July 14, 2025

PROJECT NAME: MULTI-FAMILY - 37 LAUREL PASS

PROJECT NUMBER: 2025030061

APPLICATION: MINOR SITE PLAN #32644

SITE PLAN

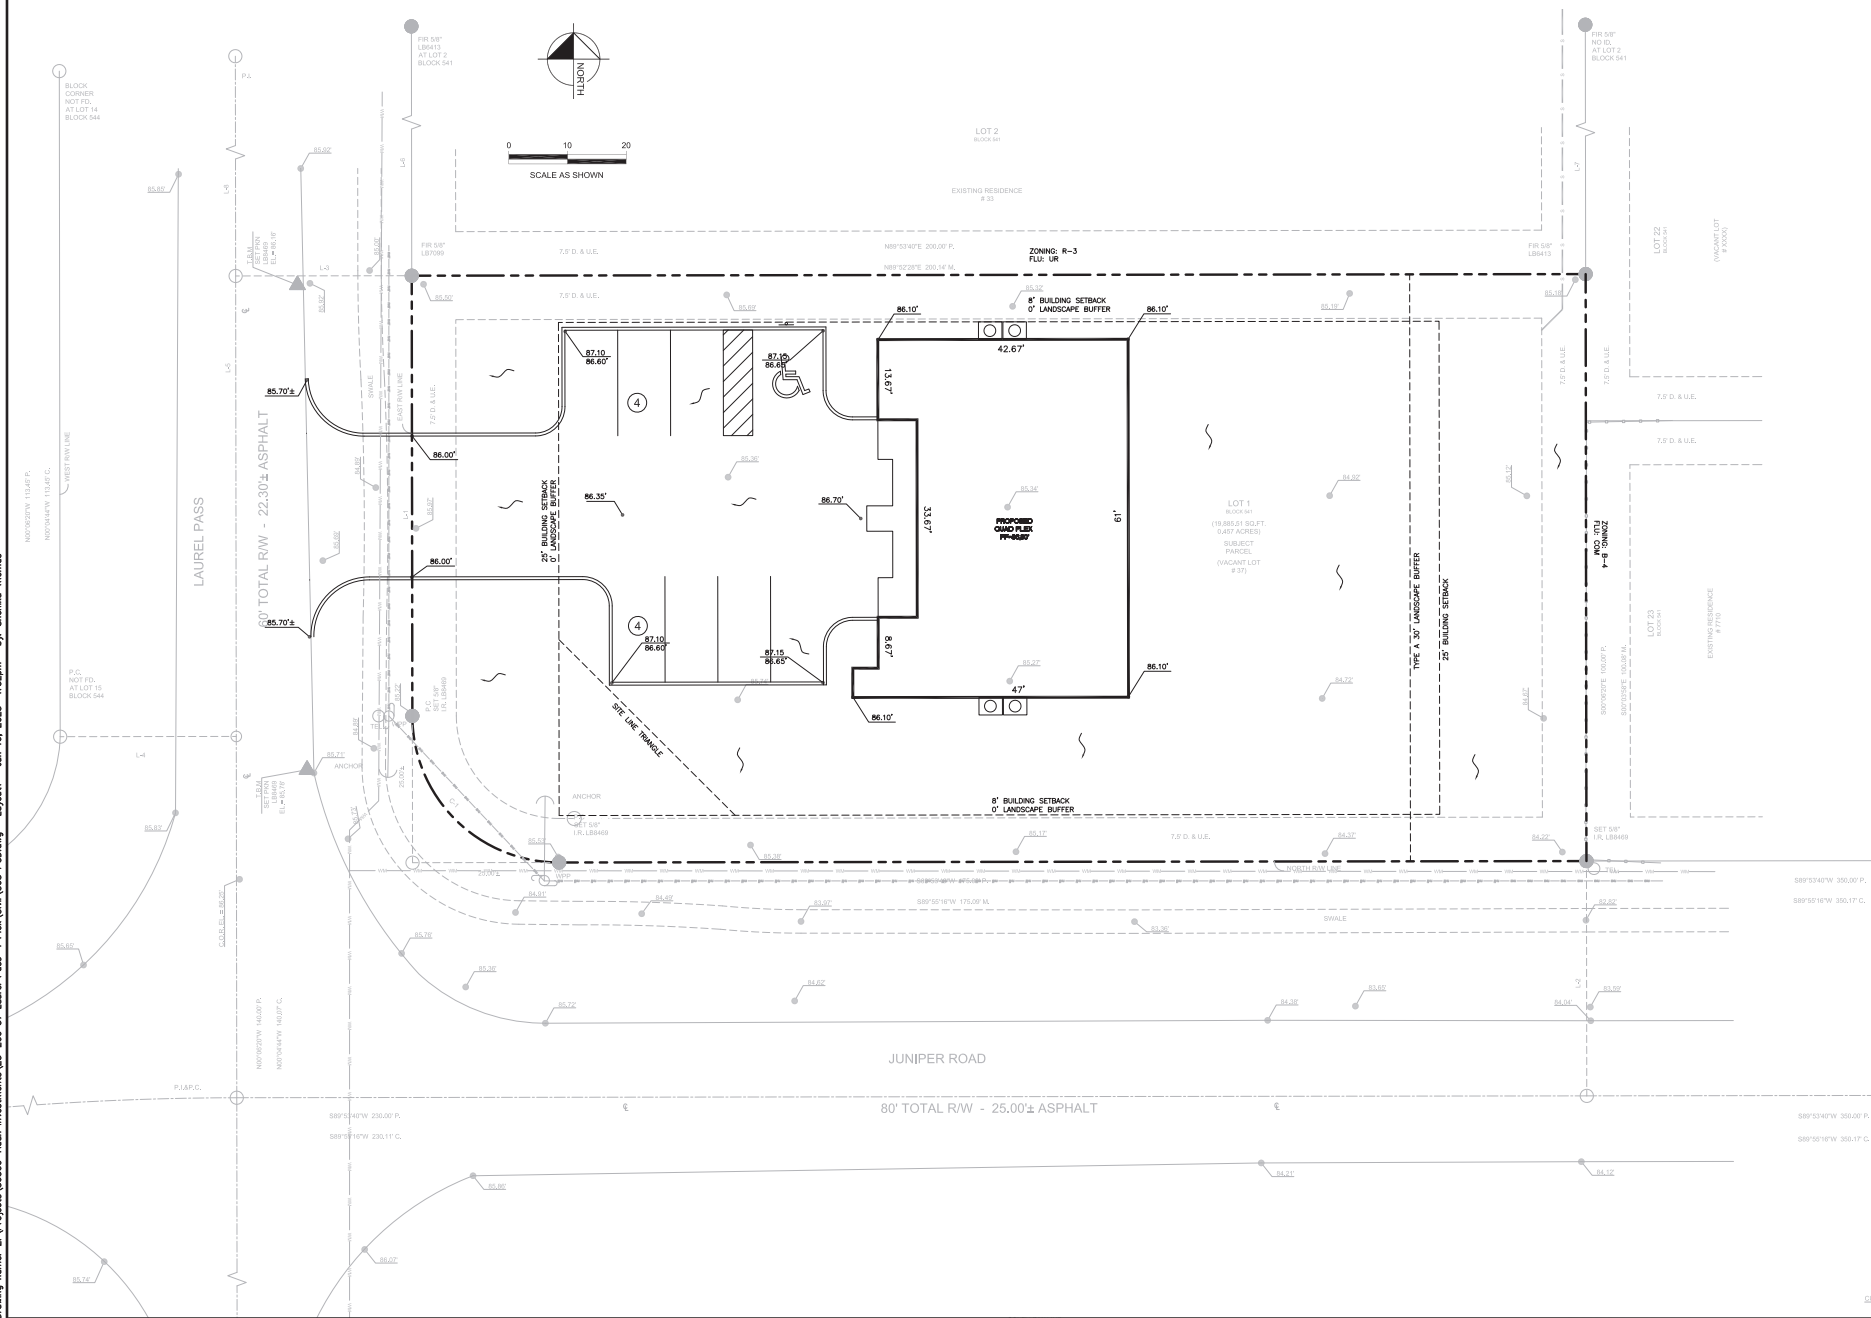
REMARKS: due to OHE, understory trees used in terminus island

- 10 DEPARTMENT: LSCAPE - LANDSCAPE DESIGN AND IRRIGATION
REVIEW ITEM: Additional Landscape comments
STATUS OF REVIEW: INFO
REMARKS: What is sight line triangle shown through part of terminus island?
